RE: **DOCKET NO. 508** – The United Illuminating Company (UI) Certificate of Environmental Compatibility and Public Need for the Milvon to West River Railroad Transmission Line 115-kV Rebuild Project that consists of the relocation and rebuild of its existing 115-kilovolt (kV) electric transmission lines from the railroad catenary structures to new steel monopole structures and related modifications to facilitate interconnection of the rebuilt 115-kV electric transmission lines at UI's existing Milvon, Woodmont, Allings Crossing, Elmwest and West River substations along approximately 9.5 miles of the Connecticut Department of Transportation's Metro-North Railroad corridor traversing the municipalities of Milford, Orange, West Haven and New Haven, Connecticut. **Partial Development and Management (D&M) Plan II – Segment 2 Revision.**

Re: Docket No. 508 - The United Illuminating Company Application for a Certificate of Environmental Compatibility and Public Need for the Milvon to West River Railroad Transmission Line 115-kV Rebuild Project – Request for Modification to Segment 2 Development and Management Plan

<table><tr> <th colspan="4">UI 115-kV RR PROJECT MILVON TO WEST RIVER DE

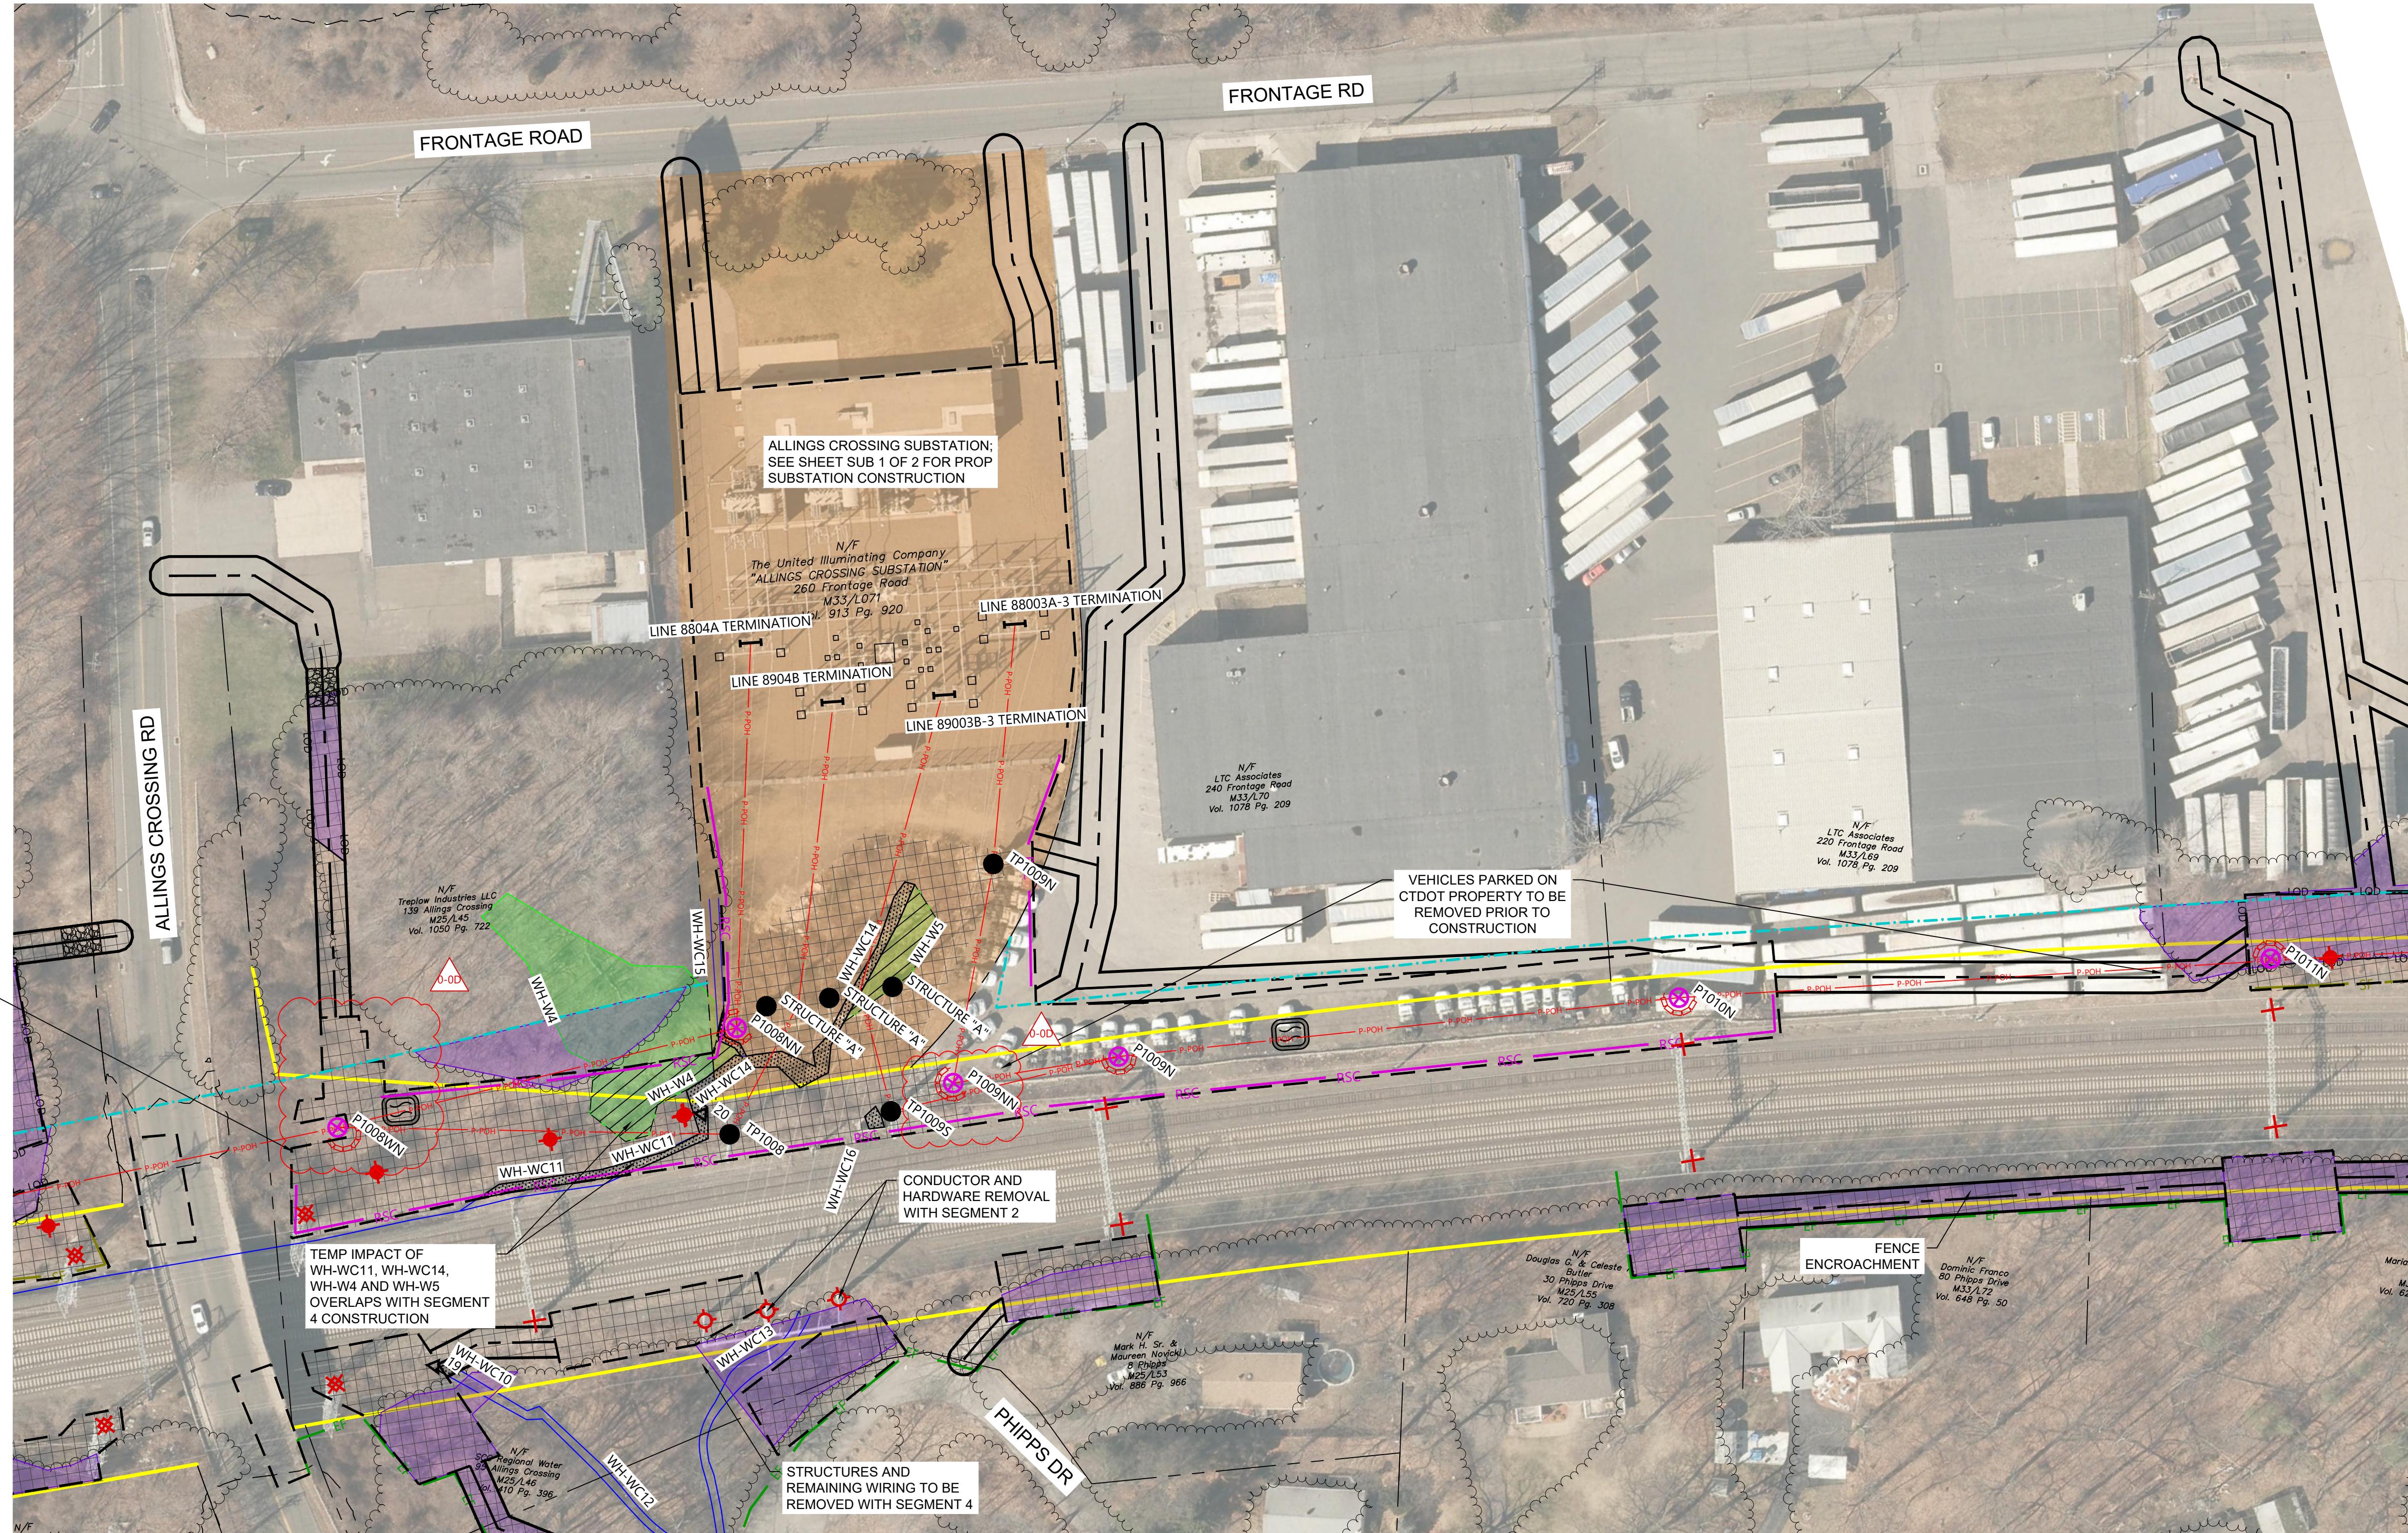
P1022N, P1023N, and P1023AN are requested to be shifted 26' to the southwest, 4' to the northwest, and 6' to the northwest, respectively. The shifting of the poles is necessary due to providing necessary clearance with MNR's communications wires on the catenary structures during construction. The poles will remain within each pole's respective work pad area. Additionally, the temporary access road associated with P1023AN will not be utilized by the contractor, reducing disturbance and clearing in this area.

P1008NN is requested to be shifted approximately 2' east and away from watercourse WH-WC15. The shifting of this pole will work in tandem with environmental controls in this area to avoid impacts to the watercourse during construction.

P1008WN is requested to be shifted 10.5' to the northeast. The shifting of this pole is necessary and at the request of the Regional Water Authority to preserve the integrity of an approximately 50-year-old water main. Minor changes to the work pad will be made to accommodate this shift.

P1009NN is requested to be shifted 10.5' east. An unmarked/unknown 36" reinforced concrete pipe (RCP) underground drainage line was discovered to be located within the planned foundation location.

- a) Relocate Structures P1022N, P1023N, and P1023AN approximately 26 feet to the southwest, 4 feet to the northwest, and 6 feet to the northwest, respectively;
- b) Eliminate use of temporary access road associated with Structure P1023AN;
- c) Relocate Structure P1008NN approximately 2 feet east;
- d) Relocate Structure P1008WN approximately to 10.5 feet to the northeast and perform minor changes to the work pad as a result of this shift; and
- e) Relocate Structure P1009NN approximately 10.5 feet east.

<table><tr> <th colspan="4">UI 115-kV RR PROJECT MILVON TO WEST RIVER DEVELOPMENT & MANAGEMENT PLAN</th> </tr><tr> <td>CK.</td> <td>JRD</td> <td>NO.</td> <td>MAPSHEET 1 OF 6</td> </tr></table>

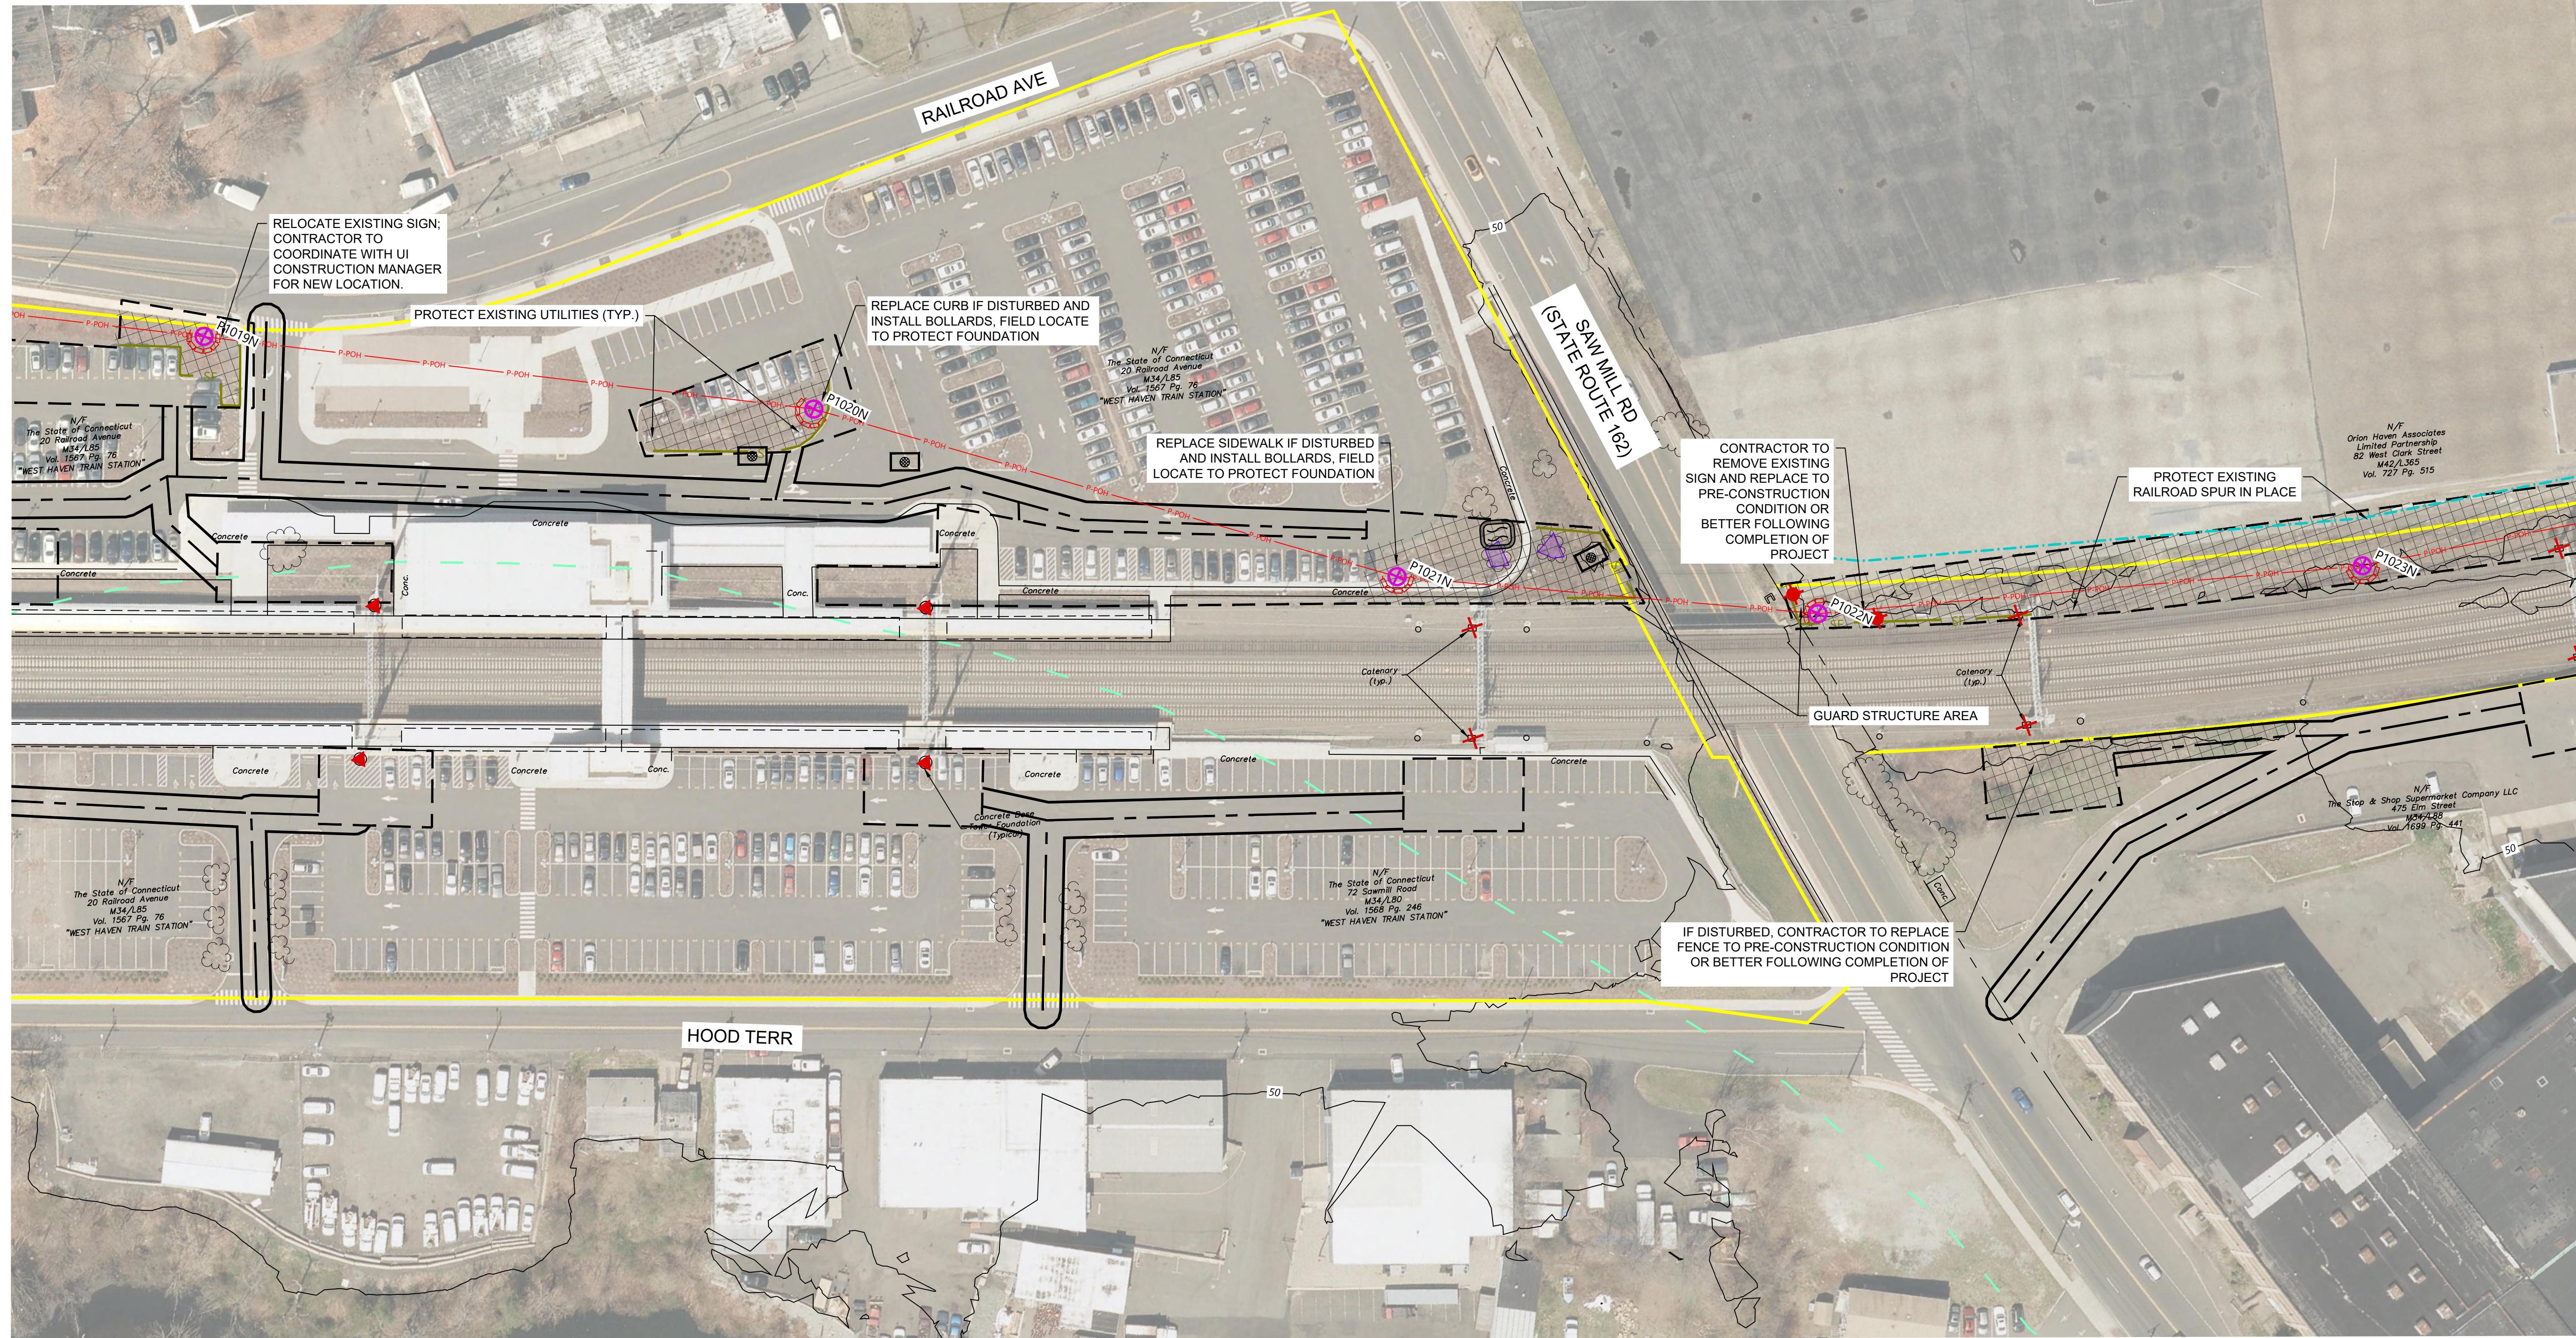
0-0D	2024/08/14	WESTWOOD	SEGMENT 2 P1009NN SHIFT AND MATTING ADJUSTMENT NEAR P1008WN	
0-0C	2024/08/09	WESTWOOD	SEGMENT 2 P1023N AND P1023AN SHIFT	
0-0B	2024/06/12	WESTWOOD	SEGMENT 2 FOR INCLUSION OF P1008NN AND P1008WN FOUNDATIONS	
0-0A	2023/05/12	WESTWOOD	SEGMENT 2 D&M PLAN FOR CSC REVIEW
